TECHNICAL EVALUATION REPORT

OVERRIDE AND RESET OF CONTROL CIRCUITRY IN THE VENTILATION/PURGE
ISOLATION AND OTHER ENGINEERED SAFETY FEATURE SYSTEMS (B-24)
TOLEDO EDISON COMPANY
DAVIS-BESSE NUCLEAR POWER STATION

NRC DOCKET NO. 50-346

April 30, 1982

Figure 1. Safety Features Actuation System

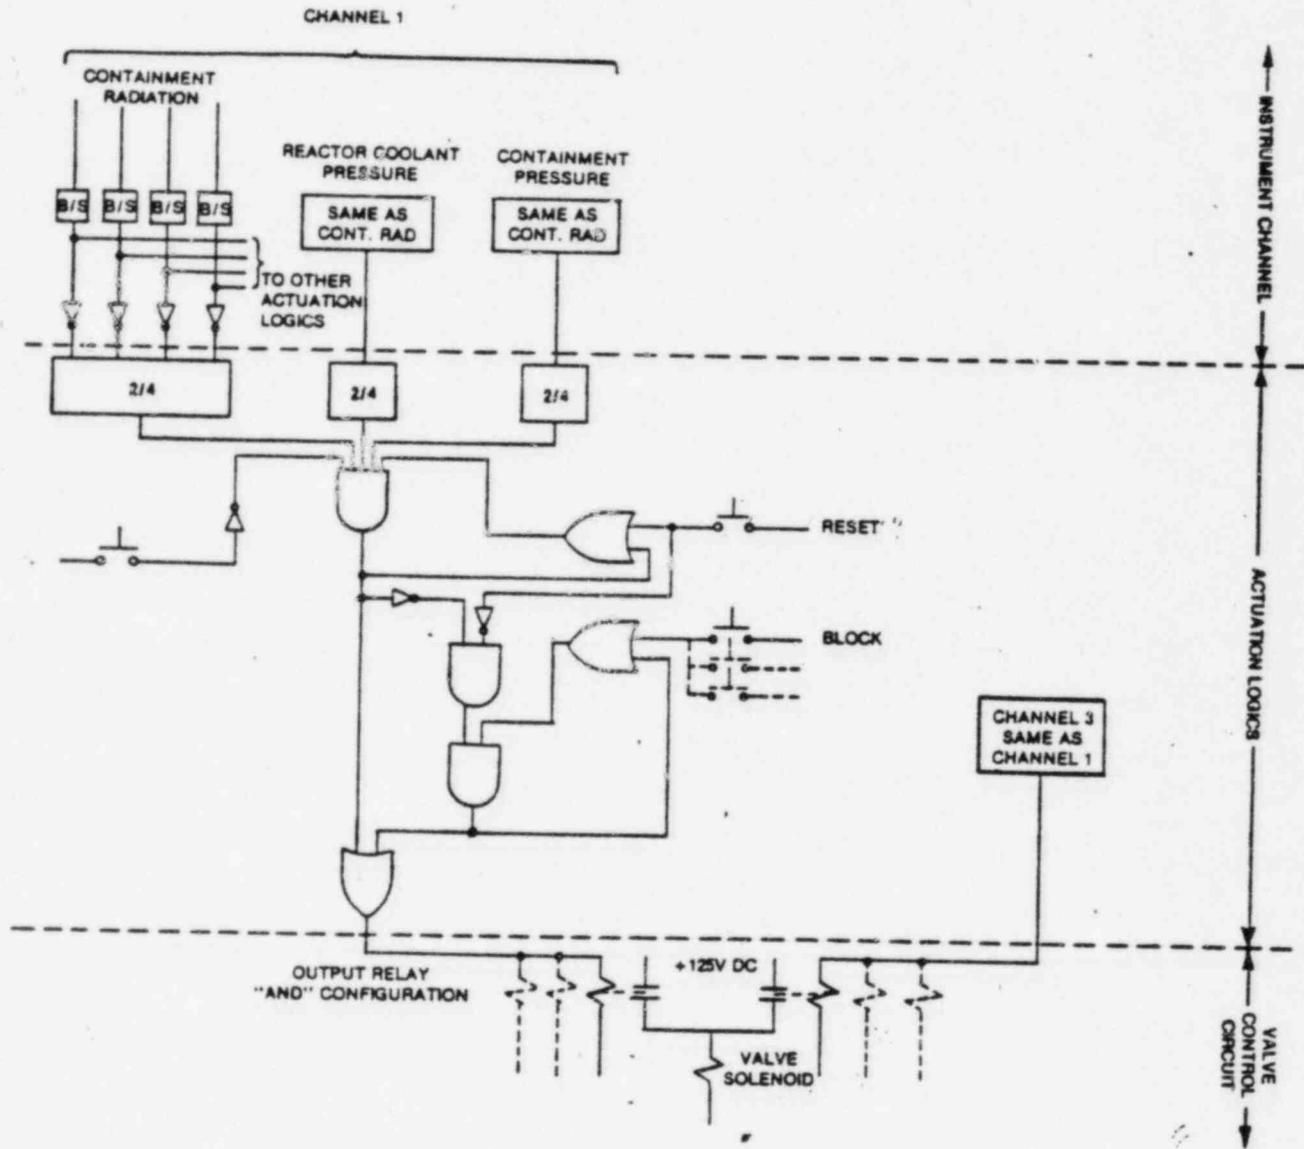
The circuit description in Section 3.1.2 shows that the capability to override an initiation signal in all the SFAS circuits exists, and once that override has been established, any further initiation signals (automatic or system-level manual) will not cause SFAS actuation. This design capability for the SFAS-controlled CVI system and other ESF systems is not in conformance with Criterion 1. In Reference 4, the Licensee committed to provide a design change at the first refueling outage following January 1, 1983, which will allow system-level manual actuation with an override present. As an interim measure, Toledo Edison has prepared a Special Order, which will be issued to operating personnel and posted on the control board, that provides precautions concerning the use of an ESF block and instructions for reactivation following a block. However, additional modifications are needed to comply with Criterion 1 as it pertains to the blocking of automatic actuation signals.

The "block" push buttons on the SFAS initiation panel (i.e., SAM panel) are not provided with any special physical features to facilitate administrative controls; therefore, they do not meet the requirements of Criterion 2.

System-level annunciation is not provided as required by Criterion 3. However, as described in Section 3.1.2, it is felt that sufficient indication of the bypass condition is provided so that the intent of Criterion 3 is met.

- o The circuit design is not in conformance with the requirements of Criterion 1. Satisfaction of the requirements will require circuit design modifications.
- o Circuit design is not in conformance with the requirements of Criterion 2. However, final evaluation of this criterion will be made when the design modifications required for Criterion 1 are submitted.
- o System-level annunciation is not provided as required by Criterion 3; however, it is felt that sufficient indication of the bypass condition is provided so that the intent of Criterion 3 is satisfied.
- o Criteria 4, 5, and 6 are satisfied in the SFAS at the Davis-Besse plant.

Figure 2. Typical Valve Control Circuit

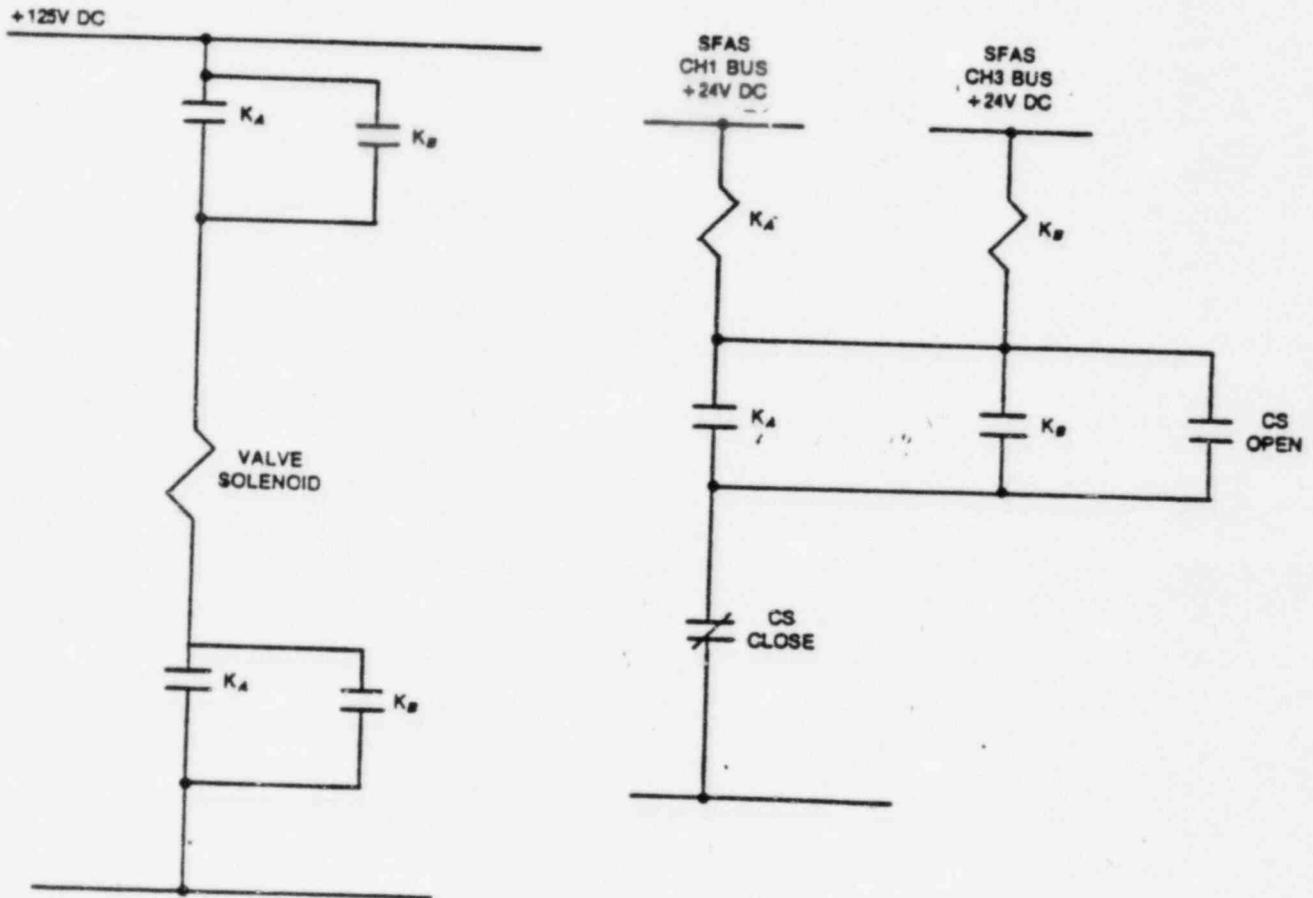
The individual valve control circuits contain contacts from the actuation logic output relays, channels 1 and 3 or channels 2 and 4 in parallel, as seen in Figure 2. This arrangement provides a logic "and" gate between two actuation logic outputs, as both sets of contacts must open to deenergize the valve control solenoid. Opening of the KA and KB contacts is accomplished by removal of the +24 V dc SFAS signal to the KA and KB relays. Manual valve operation is accomplished by use of momentary push button open/close switches. Valves will not change position upon system reset because of the KA/KB seal in contacts in the +24 V dc control system. Valve position indication is provided via limit switches.
